Planning Report

Riviera Club

Agenda Item	1
Case Number	13-114CP
Proposal	A potential new subdivision with approximately 284 single-family lots, 58 acres of open space and associated site improvements on 168 acres.
Request	Review and non-binding feedback for a Concept Plan application under the provisions of Zoning Code Section 153.050.
Site Location	8205 Avery Road West side of Avery Road, north of the intersection with Belvedere Green Boulevard
Applicant	Charles Ruma; represented by Smith and Hale.
Case Managers	Claudia D. Husak, AICP, Planner II, and Steve Langworthy, Director. (614) 410-4600, slangworthy@dublin.oh.us or chusak@dublin.oh.us
Planning Recommendation	Planning recommends the Commission consider this concept plan with respect to the land use, density, design features, and compatibility with surrounding development. The following analysis provides additional details.

13-114CP
Concept Plan
Riviera Club
8205 Avery Road

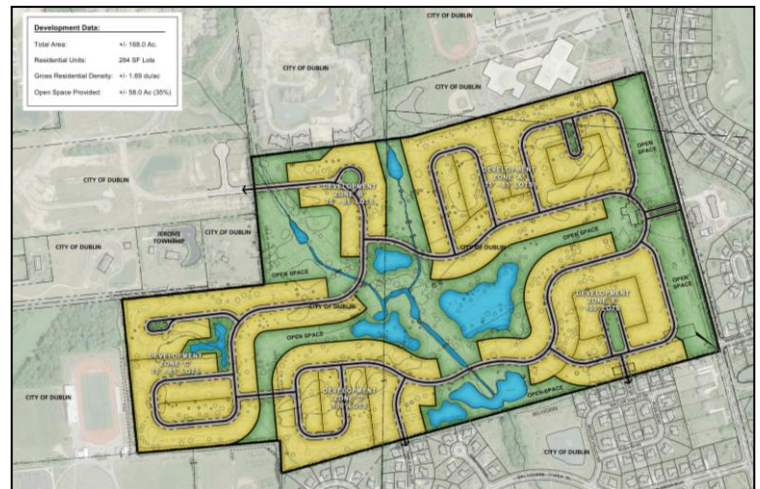
The concept plan proposal is for a single-family residential development with approximately 284 lots. The concept plan does not show individual lot lines but rather pods of residential development with varying lot width dimensions.

The plan shows several pockets of development, labelled Zones A through E, and each zone includes a certain type of single-family lot, differentiated by lot widths. Zones A through C include 75-85-foot lots and Zones D and E include 100-foot lots.

The concept includes 58 acres of open space or 35% of the site. The main access point is proposed off Avery Road in the center of the site. Secondary connectivity is proposed through Tantalus Drive and Timble Falls Drive to the south within the Belvedere subdivision and Firenza Place to the west through Tartan West to Hyland Croy Road. No direct access to Hyland Croy Road is proposed as part of this concept plan but should be investigated should this proposal move forward.

Analysis	Concept Plan
<p>3. Is the relationship of development areas to surrounding uses appropriate?</p>	<p>The development pods have been placed to either mirror or exceed the lot sizes and widths of adjacent developments. Smaller lots are concentrated along the north and west border, adjacent the school properties and multiple family homes, and larger ones at the south adjacent other single family neighborhoods. Each development pod includes some lots backing up to existing developments. Care should be taken to preserve existing trees as a natural, existing buffer from adjacent development.</p> <p>When first approved, adjacent developments to this site provided roadway connections to ensure adequate access and circulation for each existing, developing, and planned neighborhood. This permits multiple means of access for emergency vehicles as well as a means to more evenly distribute traffic without sole reliance on Avery Road. Once the Commission provides some guidance on development density, the applicant can provide a traffic impact study to determine effects on the street network and affected intersections.</p>

<p>4. Is the open space appropriately located?</p>	<p>The larger expanses of open space are concentrated along the Avery Road and the water features on the site, including the SCPZ. In some instances the potential visual impact of the open spaces is diminished by the relatively narrow segments provided. As an example, the open space west of the split of the entrance road into the site is sandwiched between development lots and misses an opportunity to provide a dramatic vista through the site.</p> <p>The other, smaller open spaces within the development pods are too small to have much visual effect or usefulness for activities. Other narrow open spaces throughout the site also lack the ability to provide useful space, or continue views, although they can be used to provide path connections where needed.</p>
Recommendation	Feedback
<p>Summary</p>	<p>The Concept Plan is the first stage when establishing a Planned Unit Development District to allow staff and the Planning and Zoning Commission to provide non-binding feedback to an applicant regarding the intended land use and development pattern. Planning recommends the Commission consider this Concept Plan with respect to the Community Plan in terms of use, and compatibility with surrounding development. Outlined below are the suggested questions to guide the Commission discussion.</p>
